MEMORANDUM

**Re: Adequacy Review of Exhibit 6.5 – Geotechnical Stability Adequacy Response
Aggregate Industries; Tucson South Resource; File No. M-2004-044; AM-01**

The Division of Reclamation, Mining and Safety (Division/DRMS) has reviewed the Slope Stability Analysis adequacy response by Tetra Tech dated July 3, 2019 for the Tucson South Resource 112c permit amendment application (AM-01). The Applicant will need to address the following adequacy items identified in the review:

Project Tucson South AM
C-1 - Static

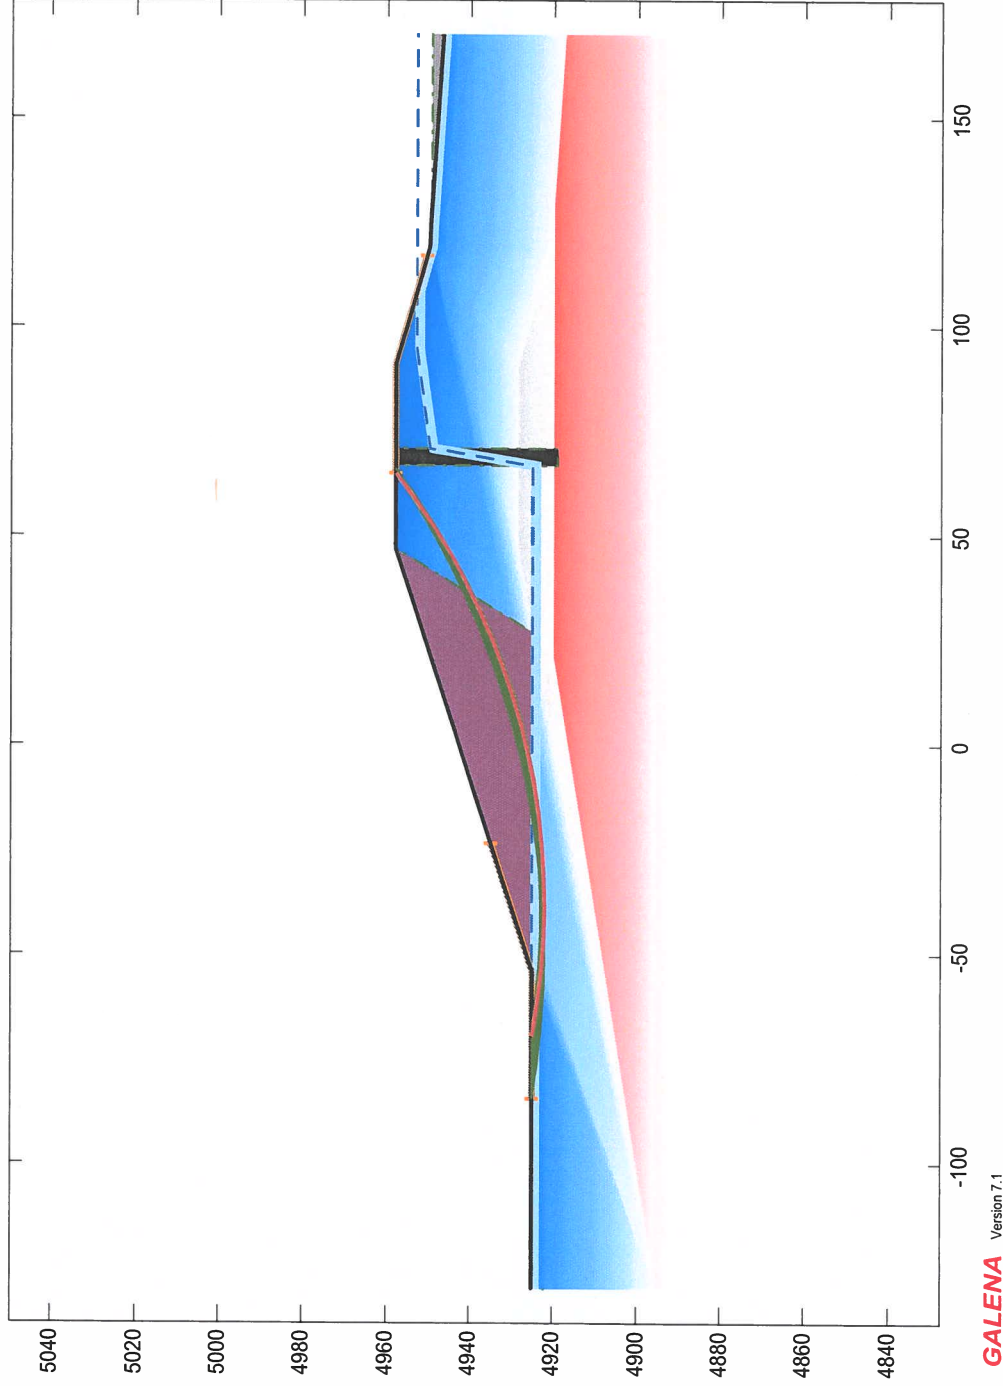
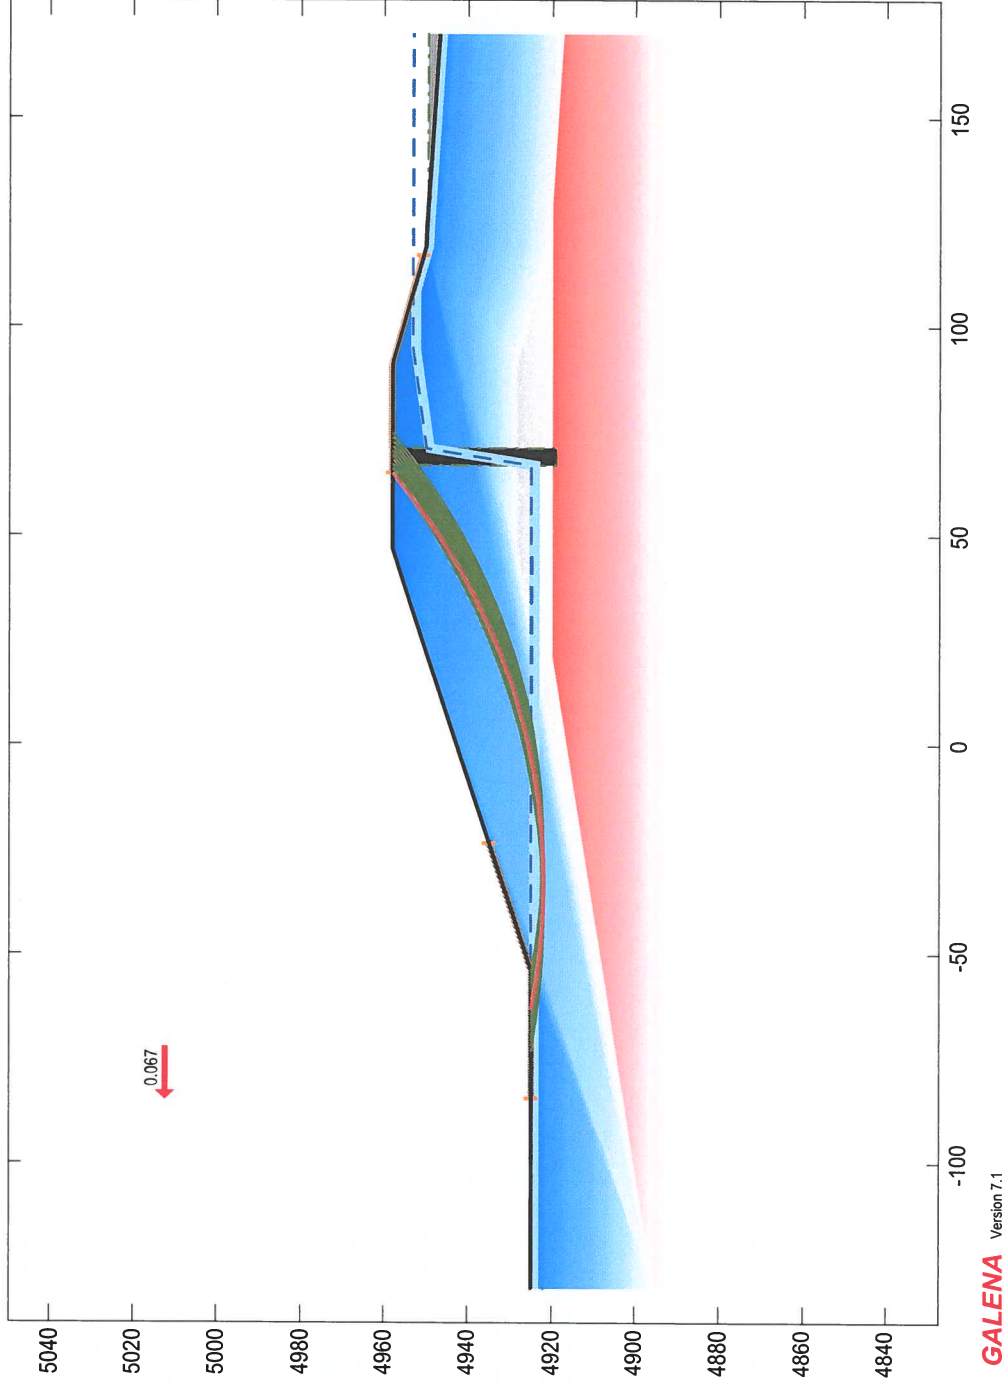
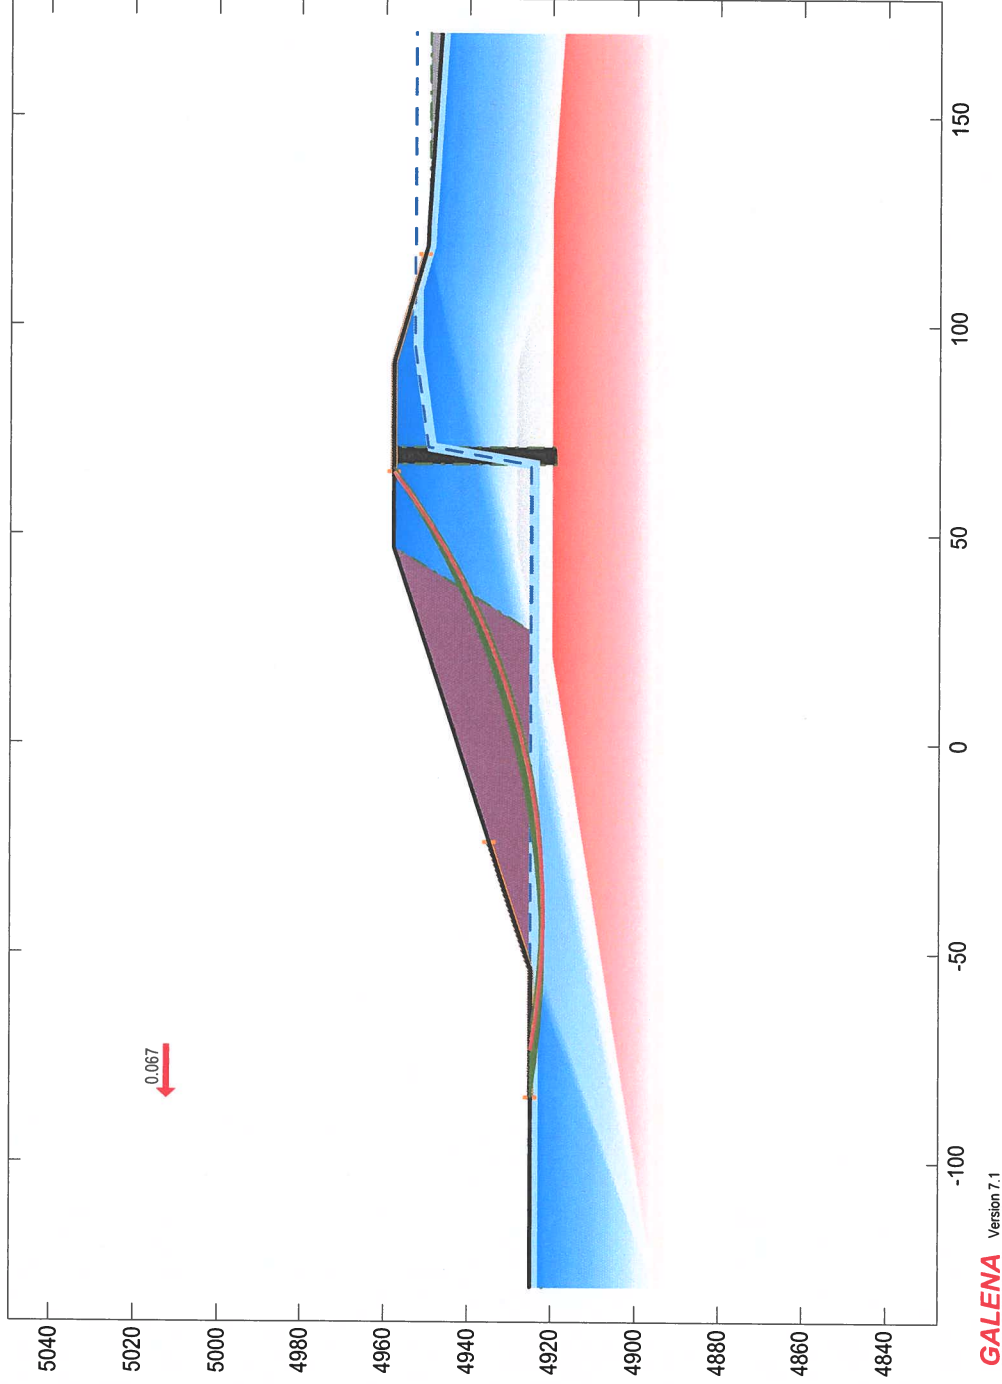
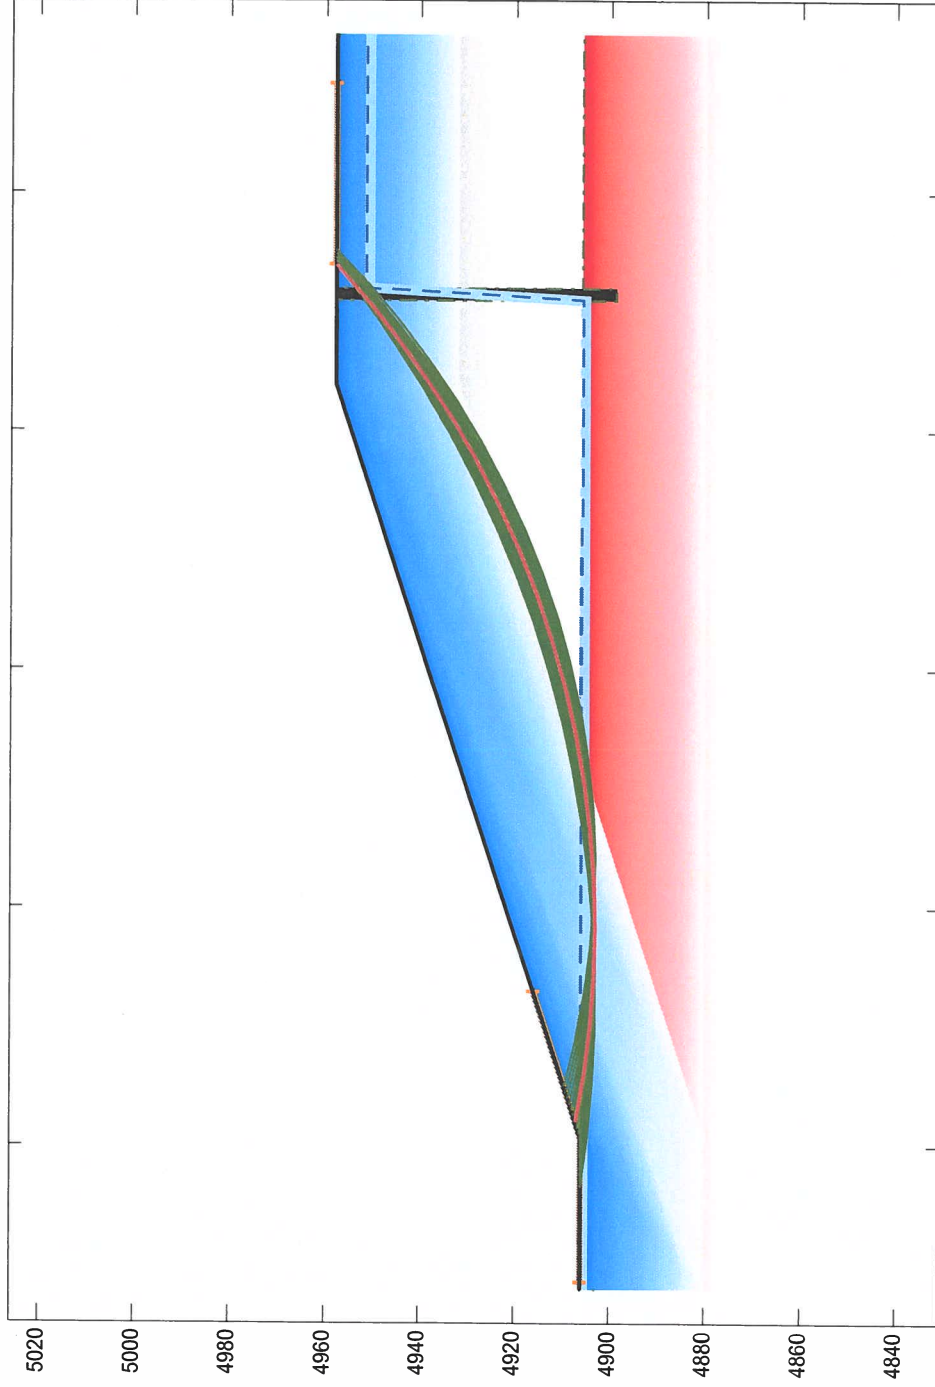
1. The Applicant modeled the Figure C analysis with a 44 feet offset from the top of bank (tob) of the South Platte River to the top of the mine slope. The Exhibit C-3 Map indicates the Applicant modeled a 42 feet offset. Please explain this discrepancy and revise the Figure C models and/or the Exhibit C-3 Map accordingly.

Project Tucson South AM
D-1 - Static

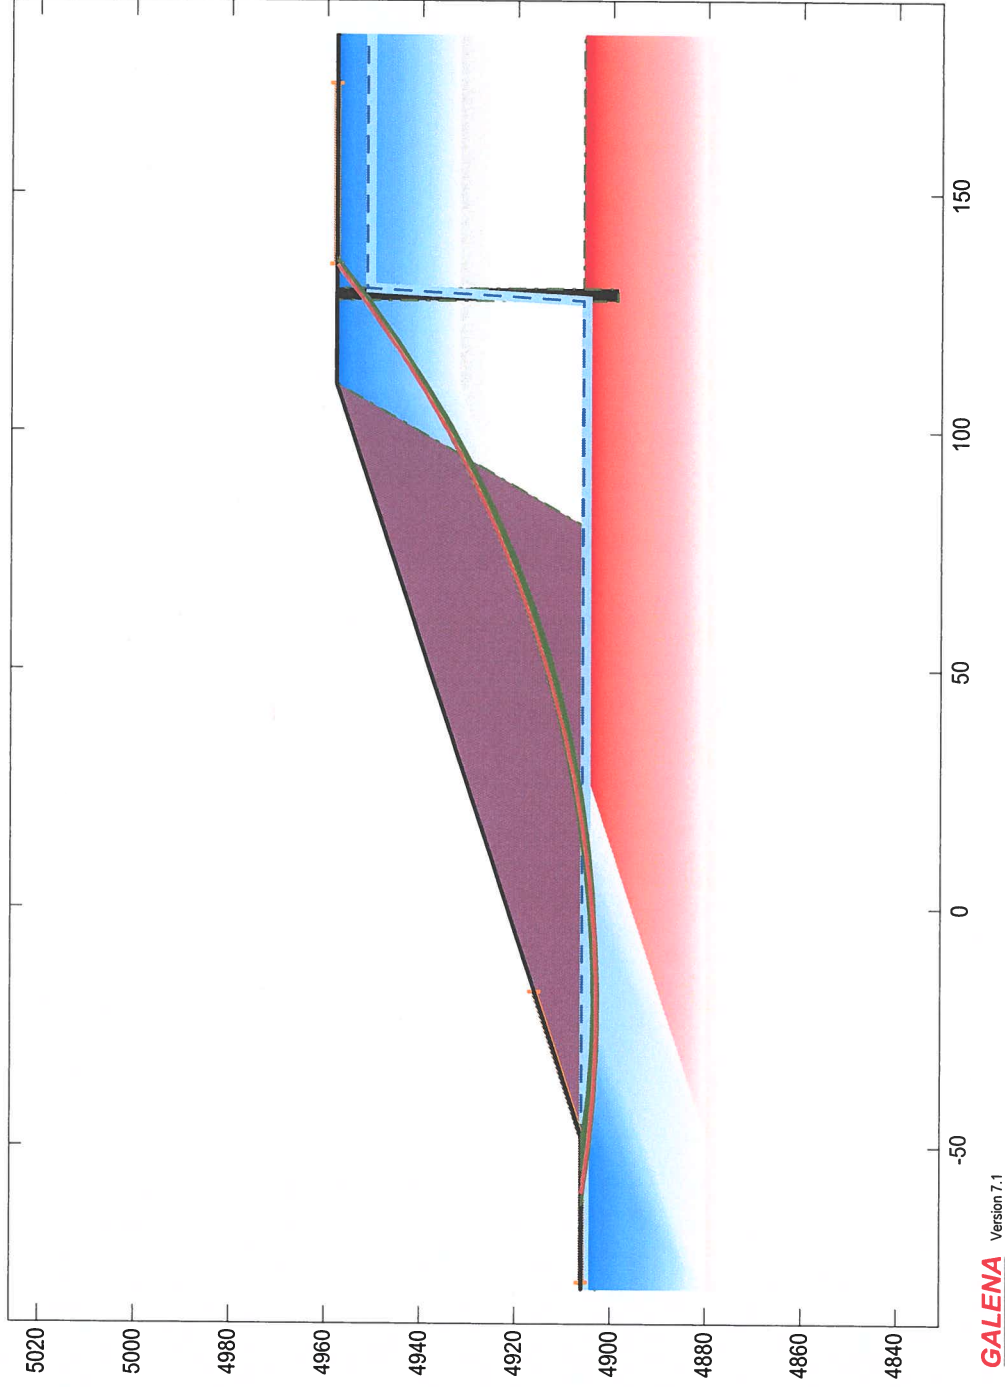
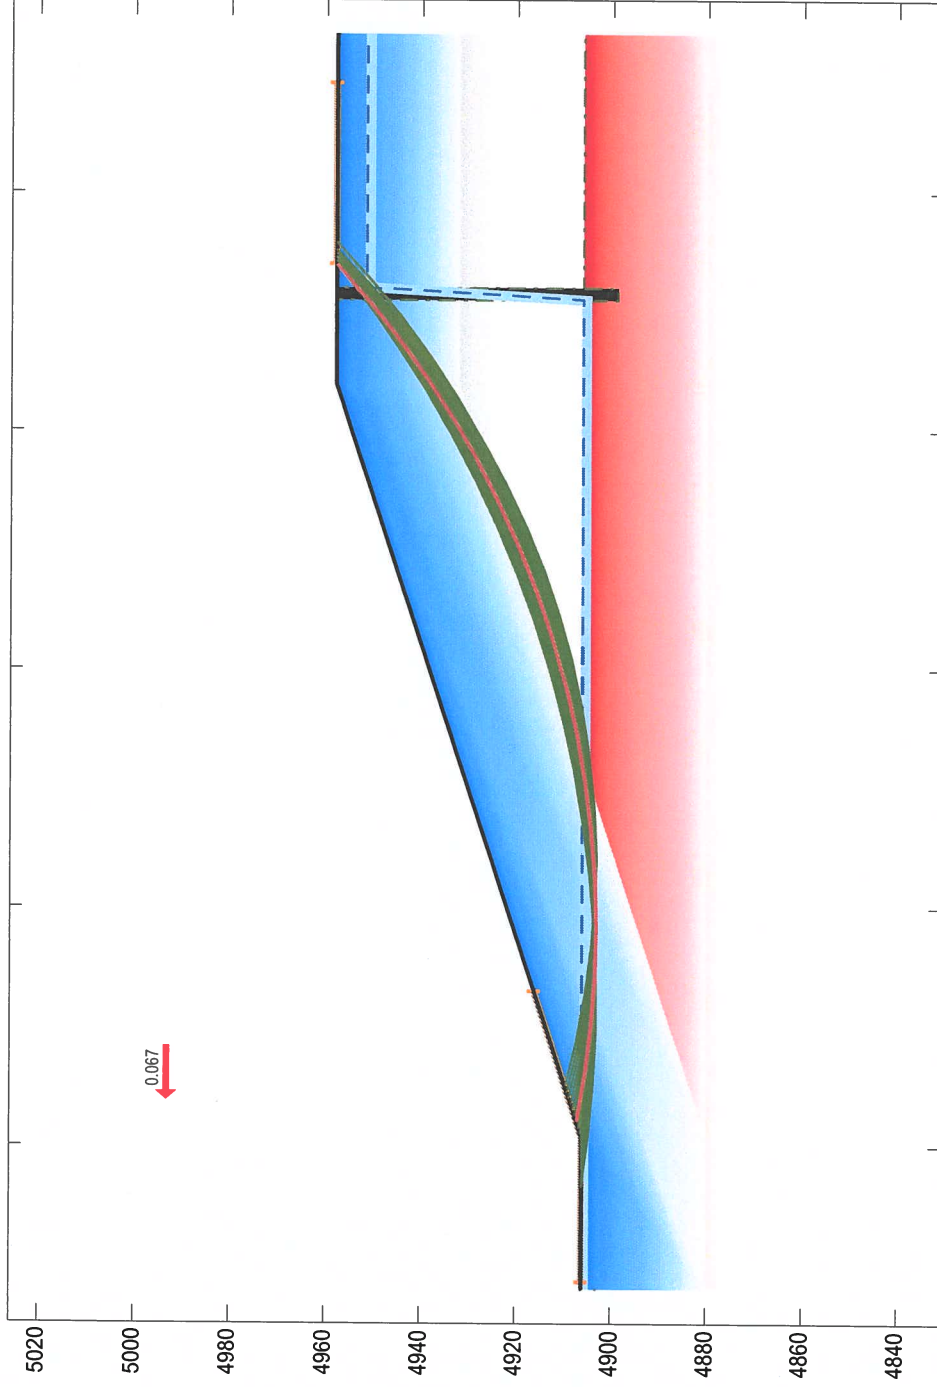
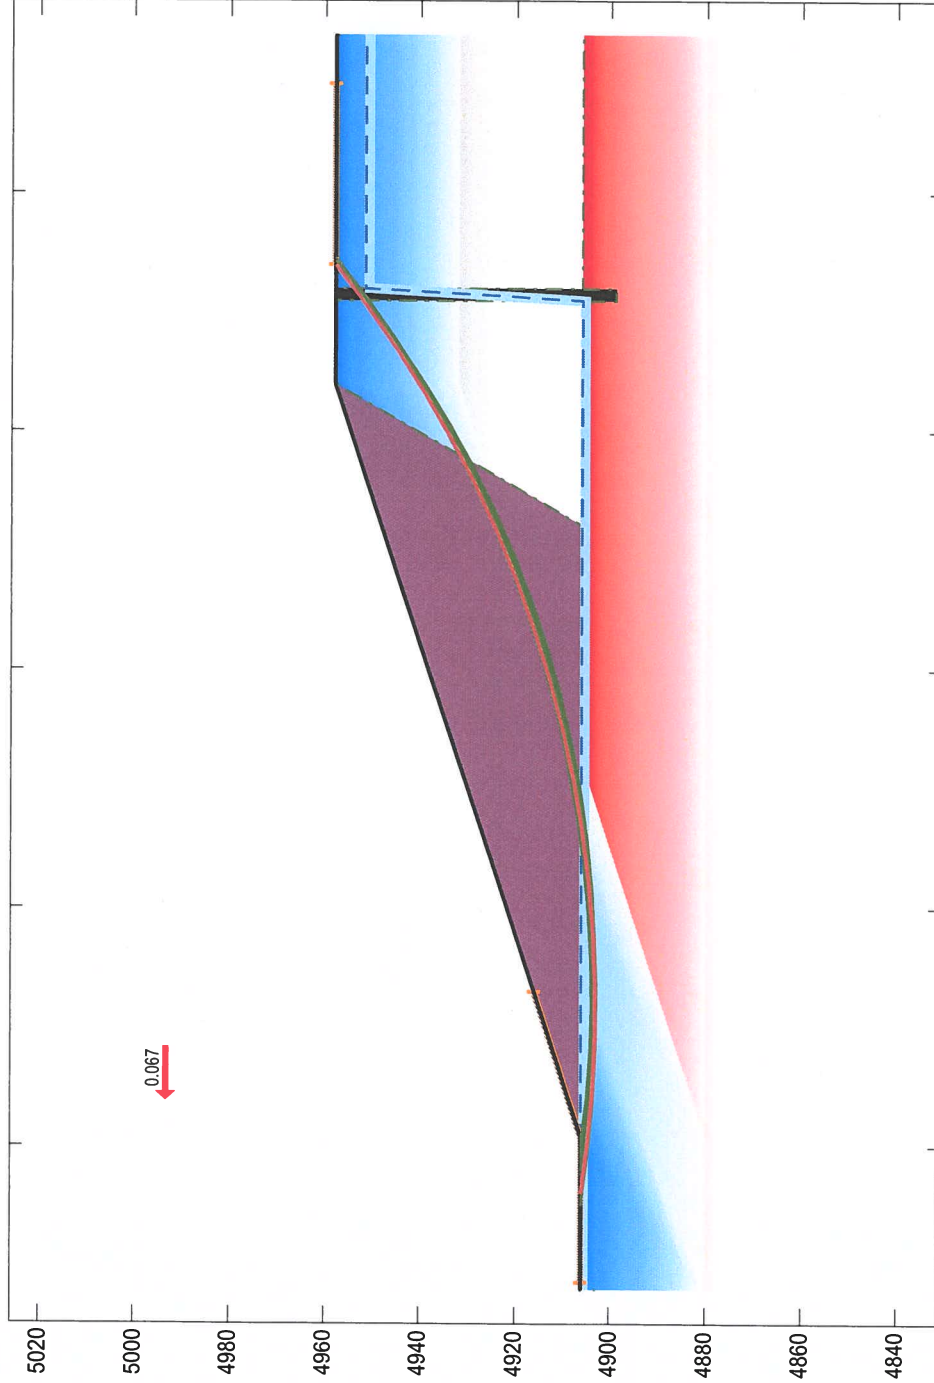
2. The Applicant modeled the Figure D analysis with a 35 feet offset from the pipeline easement to the top of the mine slope. The Exhibit C-3 Map indicates the Applicant modeled a 45 feet offset. Please explain this discrepancy and revise the Figure D models and/or the Exhibit C-3 Map accordingly.
